# UNITED STATES PATENT AND TRADEMARK OFFICE

10/823,229

<b>Office Action Summary</b>	<b>Application No.</b> 10/823,229	<b>Applicant(s)</b> TAKEUCHI ET AL.	
	<b>Examiner</b> Jeanette E. Chapman	<b>Art Unit</b> 3633

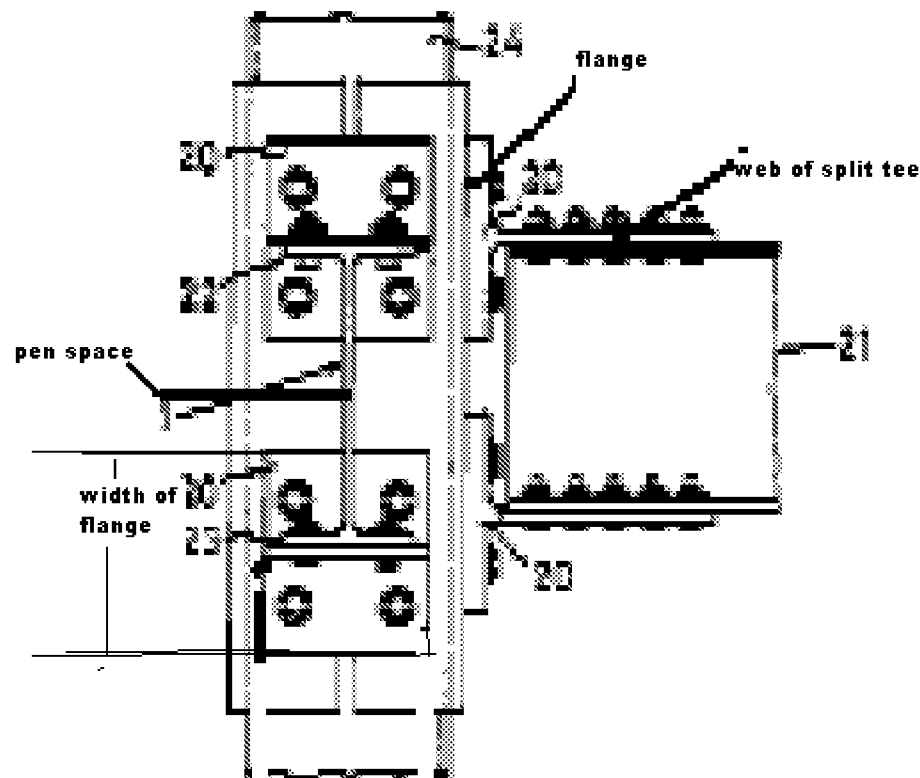
Furuumi further discloses, at a portion where both ends of the flange of the one split tee are connected to the steel column using bolts, space keeping members 2 are inserted between the flange 20 of the one split tee and the steel column 24 to provide a an open space between the flange of the one split tee 20 and the steel column 24, wherein the web 22/23 of the one split tee has an extended direction parallel to the longitudinal direction of the steel beam 21, the flange of the one split tee 20 has a width perpendicular to the axis of the column 24, and the flange of the one split tee 20 and the steel column are connected in the state of maintaining the open space across the entire

width of the flange at least at a region corresponding to the extended direction of the web of the one split tee, see annotations on patent copy;

Applicant's arguments with respect to claims 8-9 and 14-20 have been considered but are moot in view of the new ground(s) of rejection. To clarify however JP 469 discloses an open space across the entire width of the flange. See annotations on patent copy above. Further Byfield and Matsuo have not been bodily incorporated into Furuumi but cited to merely show the related art include to show the cross sectional area of the flange is partially reduced in order to provide/accommodate the fasteners and the concrete slab respectively.
